EVALUATION OF COOK IPE/HRA MATERIALS

Letter Report to U.S. Nuclear Regulatory Commission
Office of Nuclear Regulatory Research

EVALUATION OF COOK IPE/HRA MATERIALS

NRC staff asked me to review the Human Reliability Analysis (HRA) portions of the Cook Nuclear Power Plant (NPP) Individual Plant Examination (IPE). I reviewed the documentation listed in Appendix A, visited NRC staff twice, and held numerous telephone sessions with them.

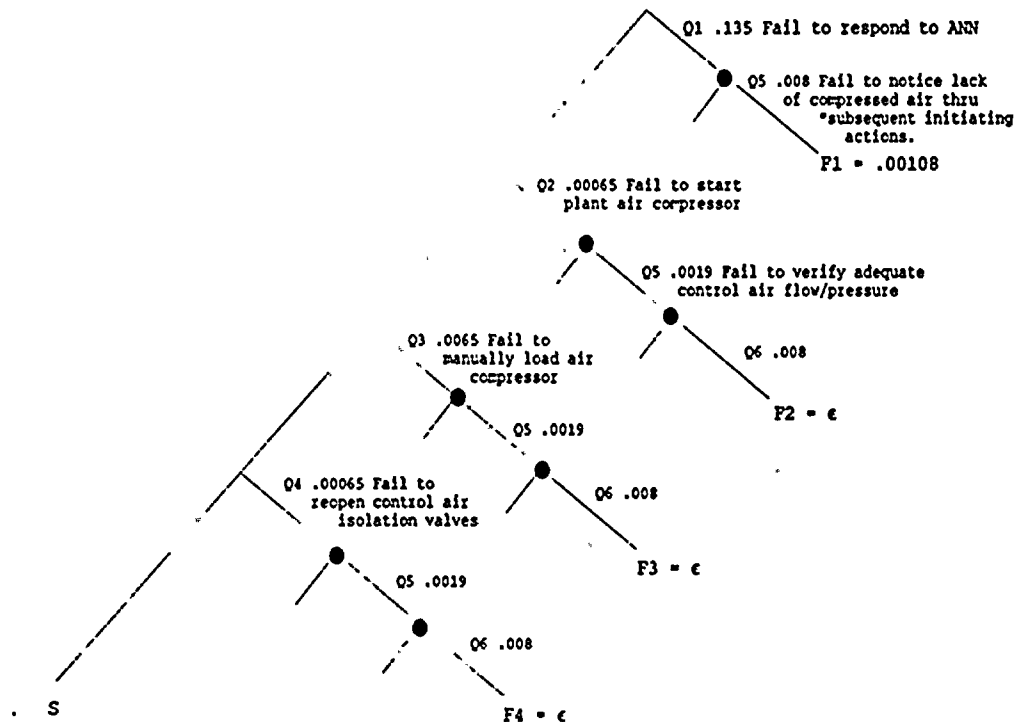
1. pp 41-43, R. Operator Fails to Restore Control Air Through Use of the Plant Air Compressor During Loss of Offsite Power:
 - a. It is difficult to envision the human actions in the equation for the HEP. It would be much easier for a reviewer, especially one with a human factors background or one used to the THERP HRA method, to employ an HRA event tree.

- b. Following is a sketch of an approximate HRA event tree in which only the failure limbs are completely drawn. One can note that each failure path through this series system ends with a potent error recovery factor (RF HEP = $8E-3$). The Q6 error is: "Operator fails to notice lack of compressed air through subsequent mitigating actions (i.e., additional valves will not open)." I don't have sufficient information to evaluate this RF, but it does result in a substantial reduction in F_T , the total failure probability for this event. Note that were it not for this RF HEP being ANDed with Q1 in the first failure path through the HRA event tree, the .135 HEP for Q1 for diagnosis error would result in a total failure probability, F_T , for this event being a factor of 125 higher.

- c. There are several misapplication of the HRA Handbook in this event:
 - 1) Q1 is a modification of item #4 in Table 20-3 (the Nominal Diagnosis Model), but the nominal HEP is modified for the effects of stress. This table already includes the effects of stress. Finally, I find the multiplier of 0.1 needs to have believable justification. (See especially the discussion in item 9.d in Table 8-1 of Ref. 4)

- 2) Q2 uses the correct tabled HEP from the HRA Handbook, but the 0.1 multiplier for "trained" is questionable. Normally, if one allows extra credit for a combination of familiarity and high skill, the lower bound of the median HEP would be used. In this case, it would be $.001/3 \sim 3E-4$. Well, that seems to work out OK, assuming the use of the lower bound can be justified. The mean HEP would then probably be around the $6.4E-4$ assessed.

- 3) Q3 sounds like an ECOM, but Table 20-7 is used as the starting point, and this table is for EOMs. I couldn't tell if this action is done in the control room or is it done outside the control room.

- 4) Q4 seems OK except for the 0.1 multiplier for training.
 - 5) Q5 seems OK except for the 0.1 training multiplier. But what directs the operator to perform this step?

- 6) Q6 like all the other terms is multiplied by 0.1 for "trained." This is certainly a convenient way of reducing estimated HEPs, but the use of such a "correction factor" across the board is questionable. Also I wonder how much time is available for this generic RF.

- 7) No dependence is assessed among any of the operator actions. This may be OK; I don't know enough about the details to judge whether it is OK or not. But typically an analyst will assess independence between EOMs for written steps in a procedure. There are exceptions, however.
